| ROADWAY PLAN                                                         |                                                    |
| INTERSTATE ROUTE H-1 RESURFACING                                     |                                                    |
| Miller Pedestrian Overpass to Kapiolani Interchange                  |                                                    |
| Federal-Aid Project No. NH-HI-1(279)                                 |                                                    |

| SHEET No. R21 OF 41 SHEETS                                                                                                      |                                                          |

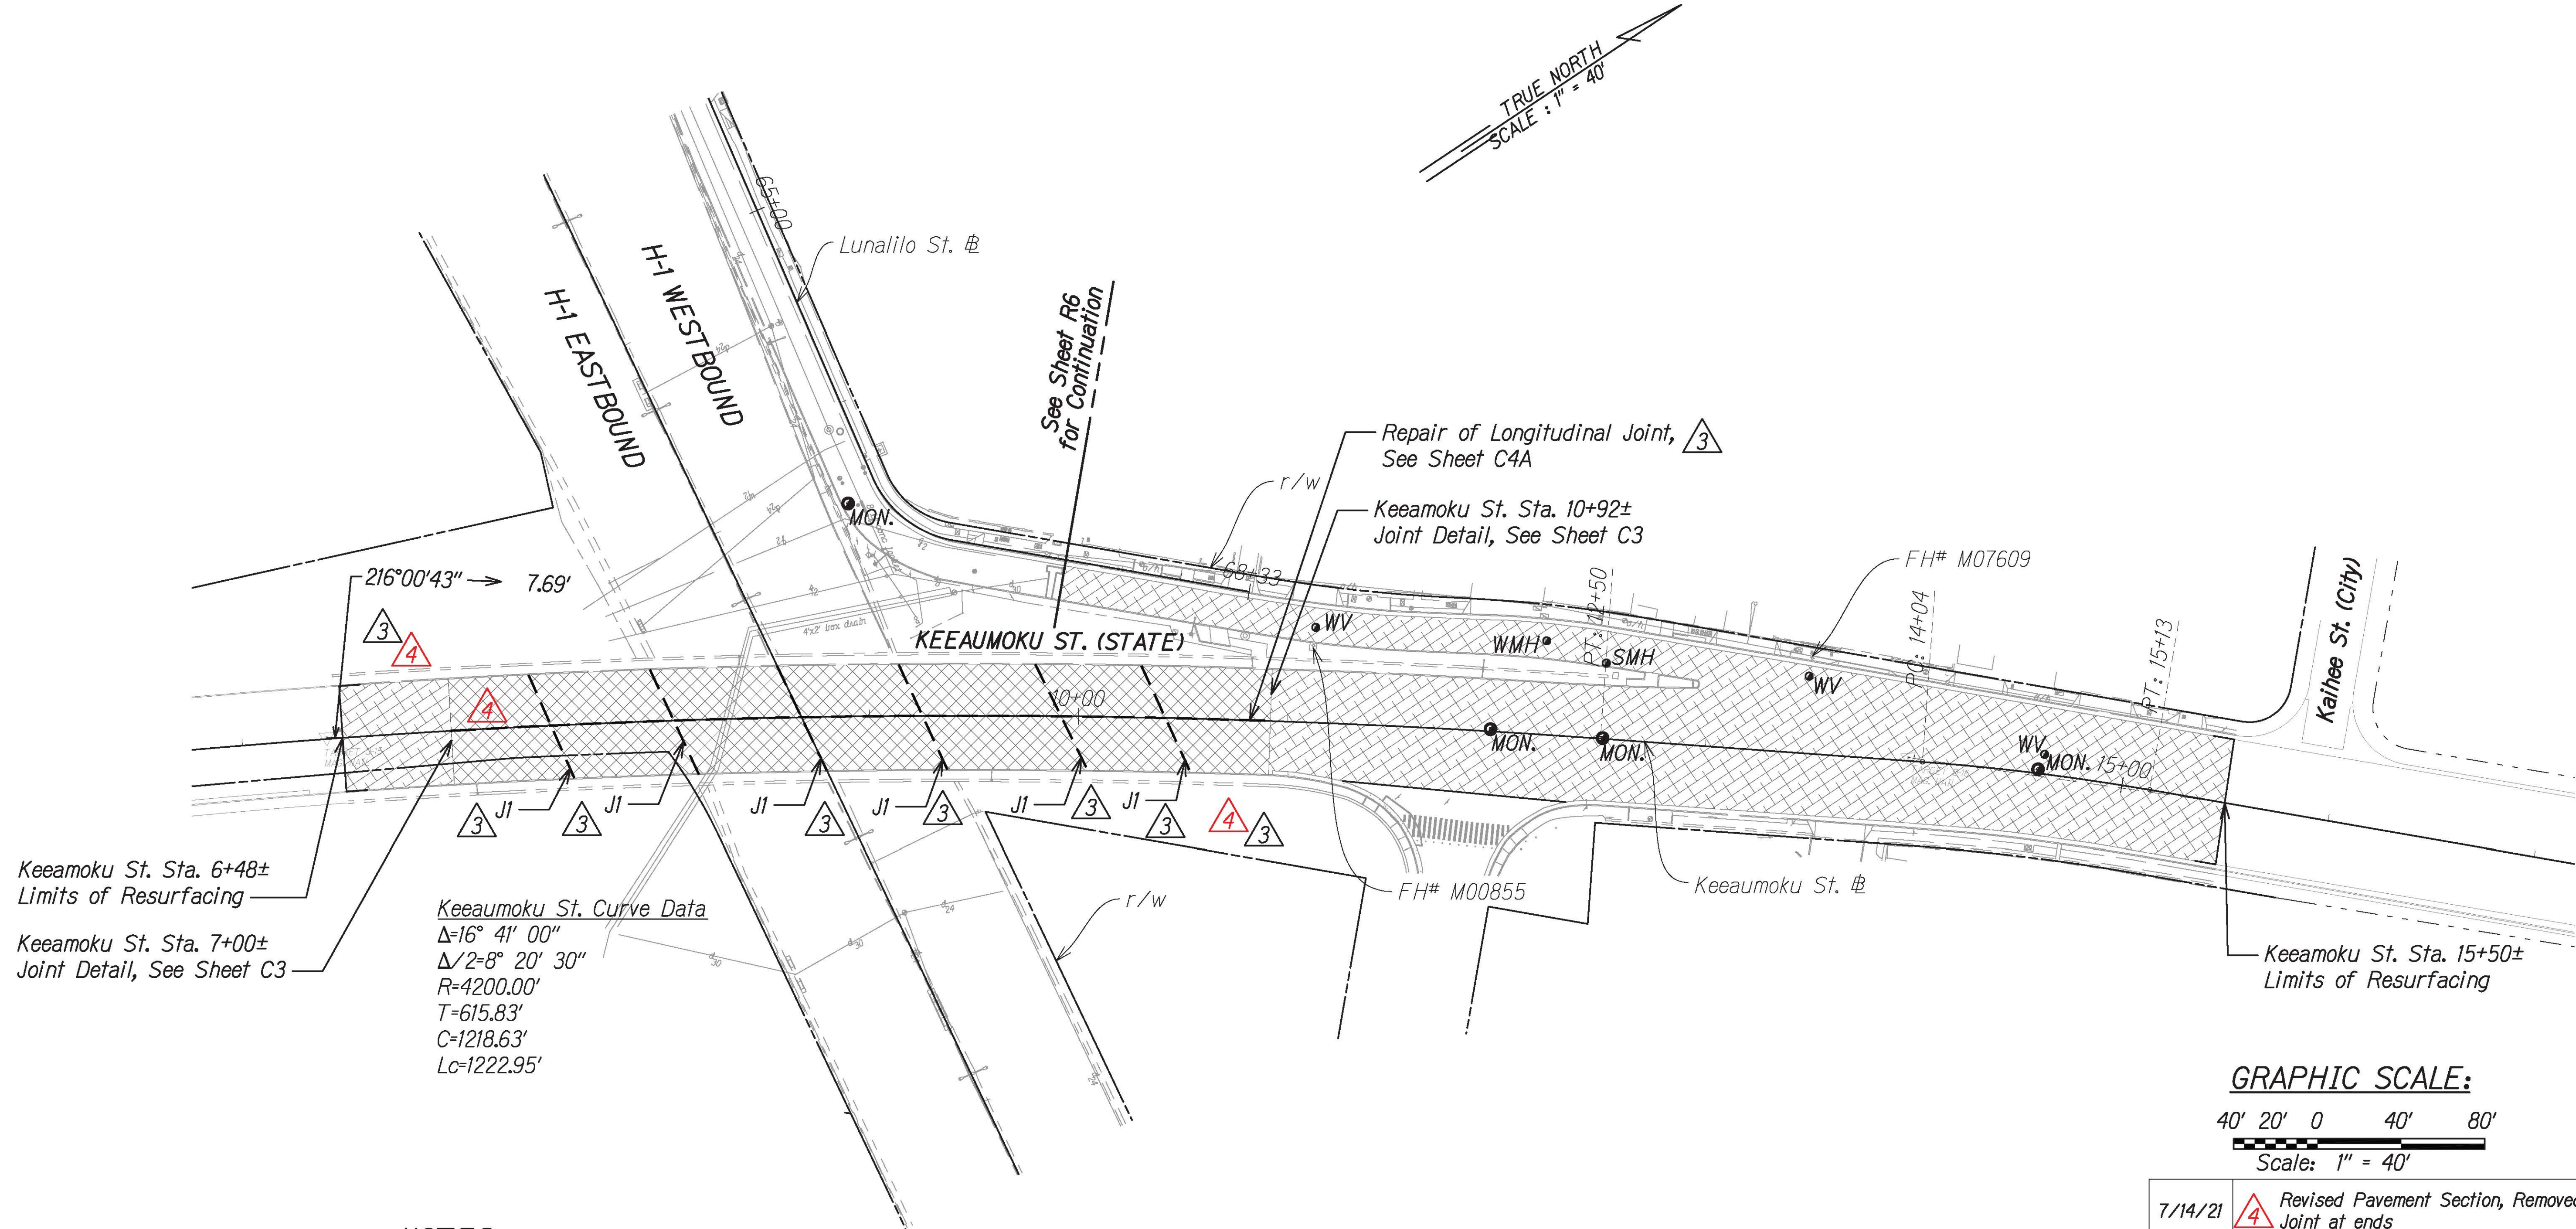
| 7/14/21                                                                                                                         | [Symbol] Revised Pavement Section, Removed Joint at ends |
| 7/9/21                                                                                                                          | [Symbol] BWS Tracings, Added Repair Joint                |

| SHEET No. R22 OF 41 SHEETS                                                                                                      |                                                     |

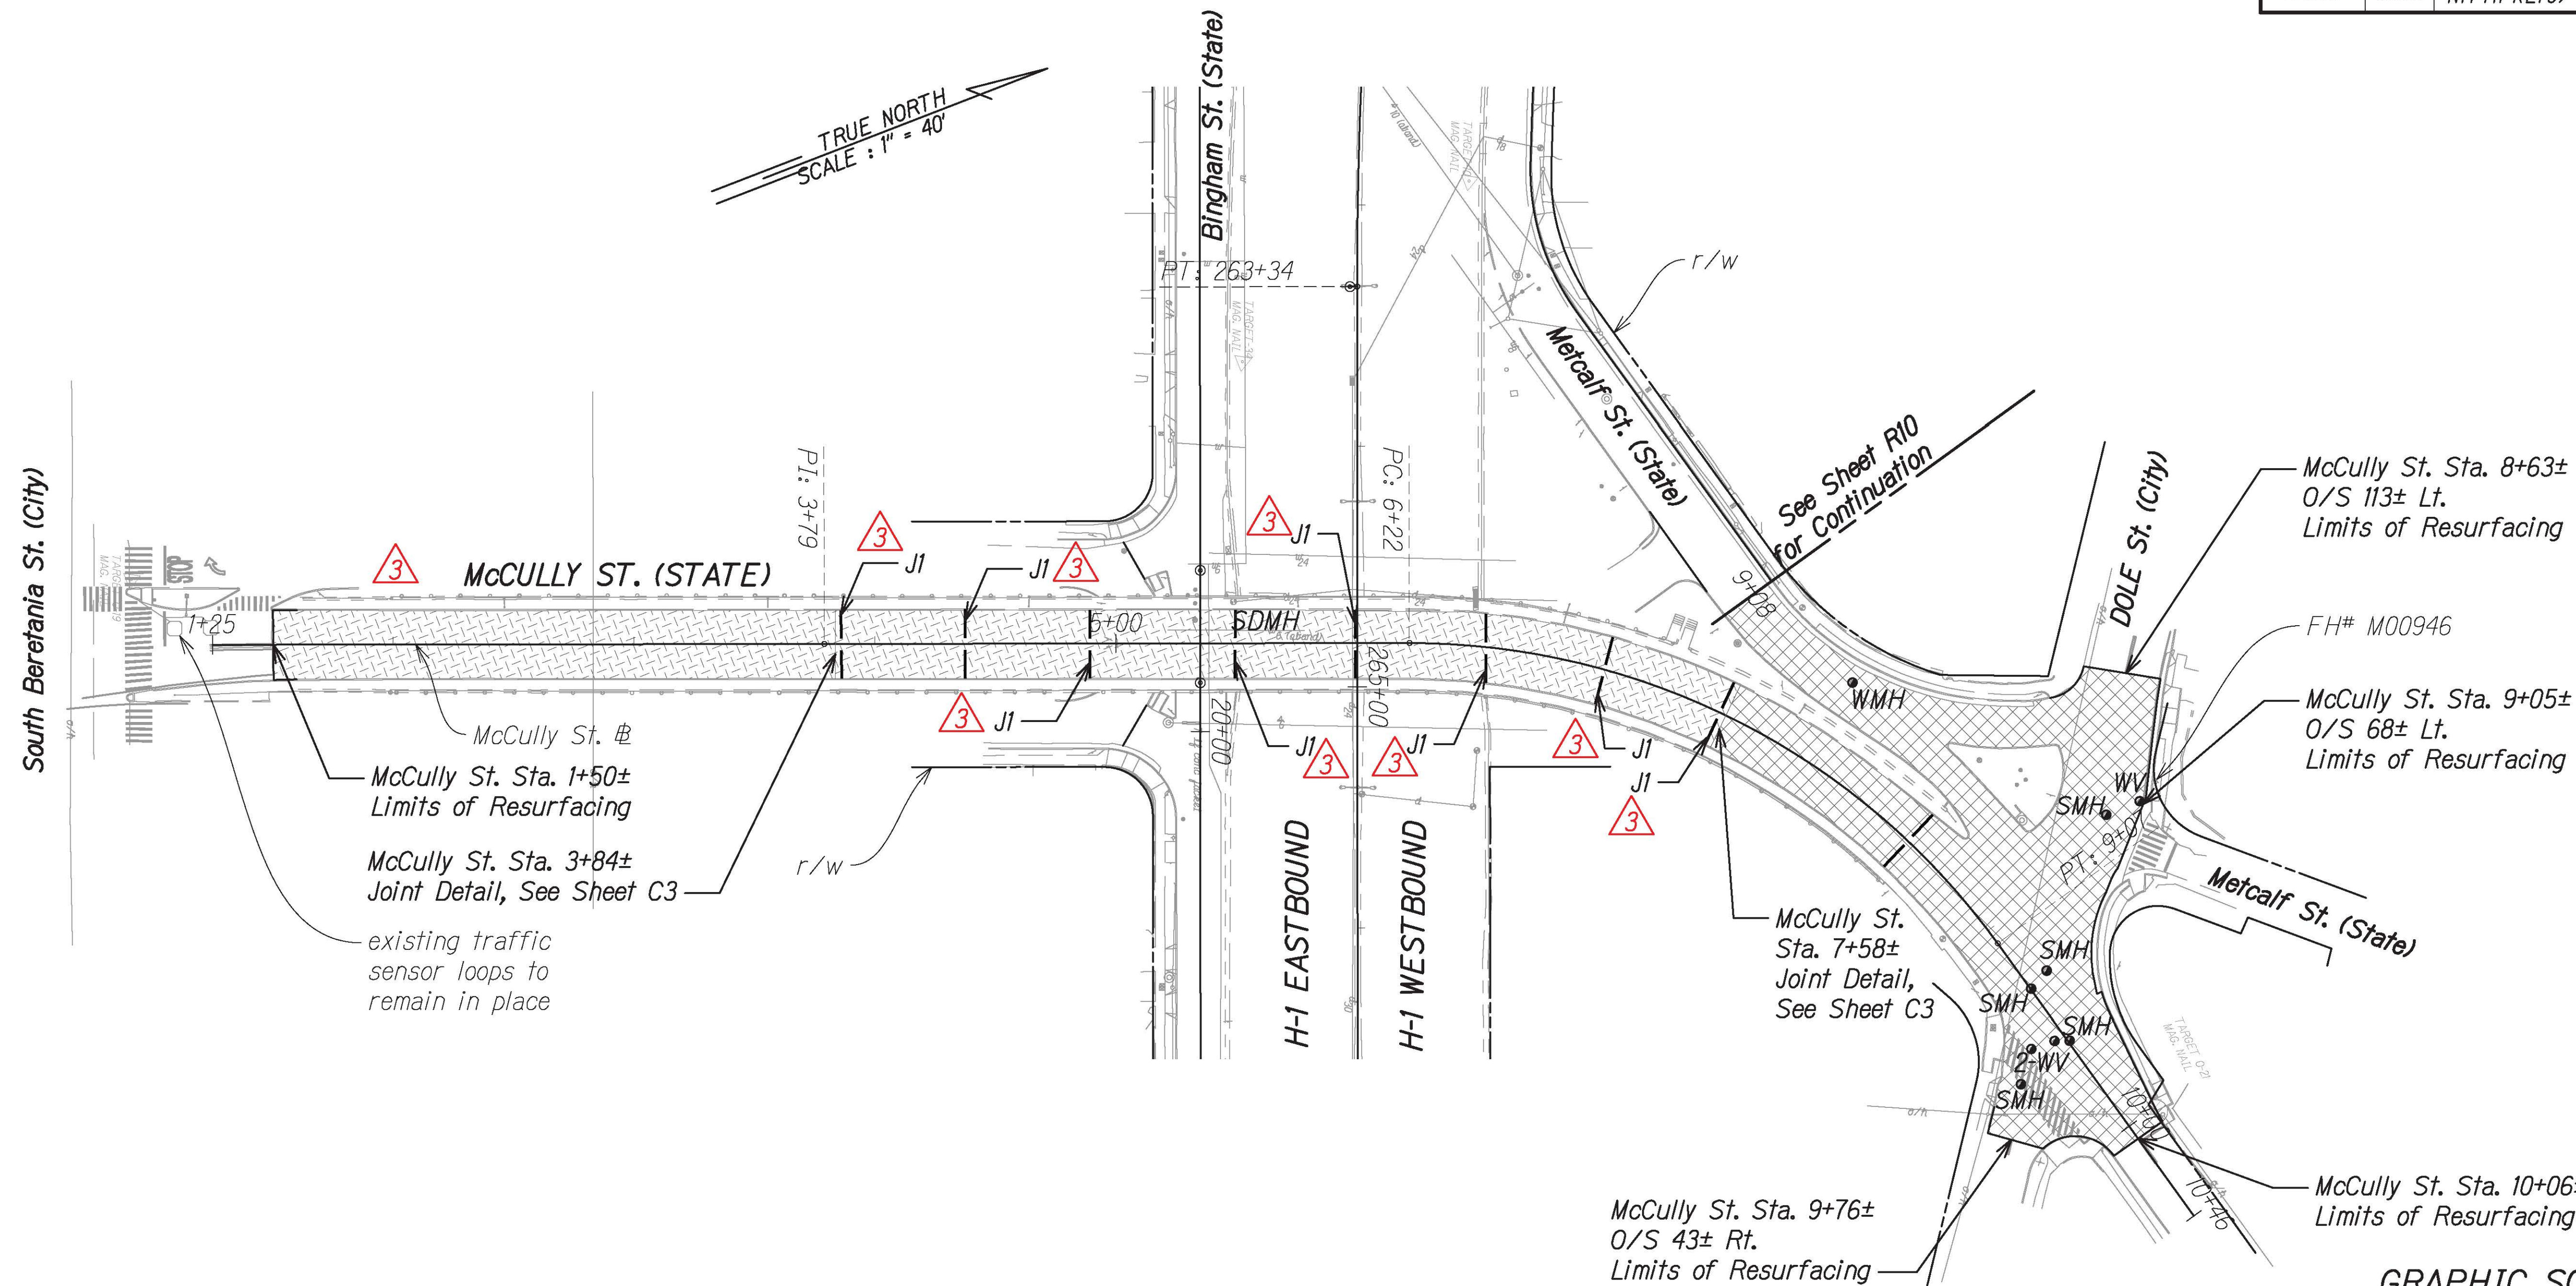
| 7/9/21                                                                                                                          | BWS Tracings, Added Repair Joint, Added Resurfacing |

| SHEET No. R23 OF 41 SHEETS                                           |                                                                                                                                                                          |

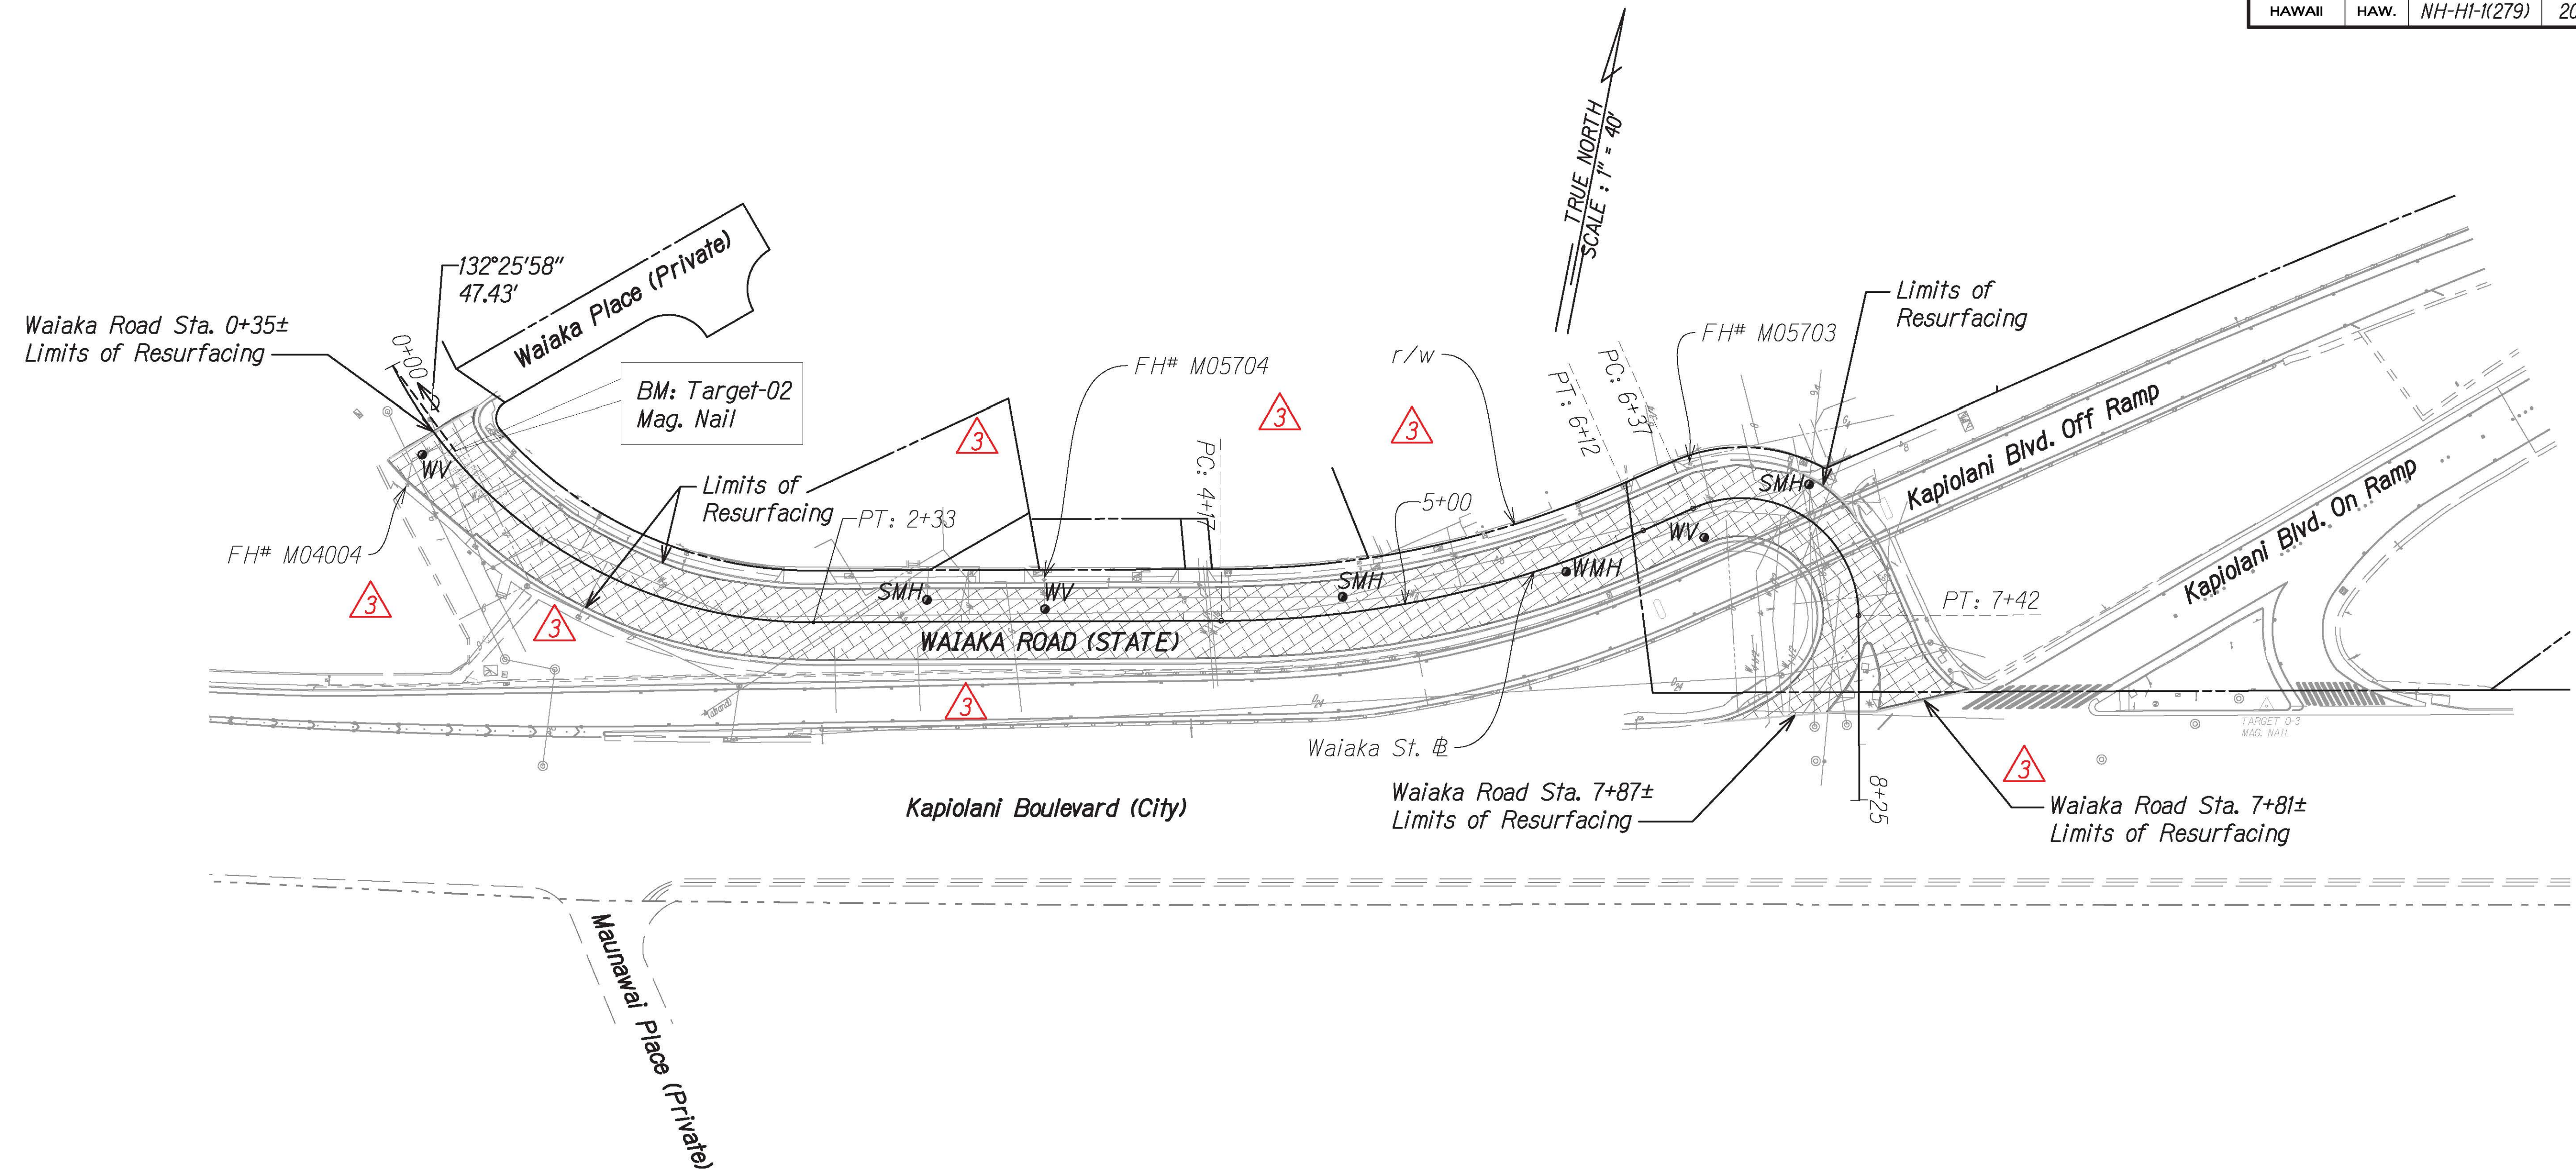
| 7/9/21                                                               |  BWS Tracings, Removed Pavement<br>Reconstruction Areas, and Revised<br>Resurfacing |
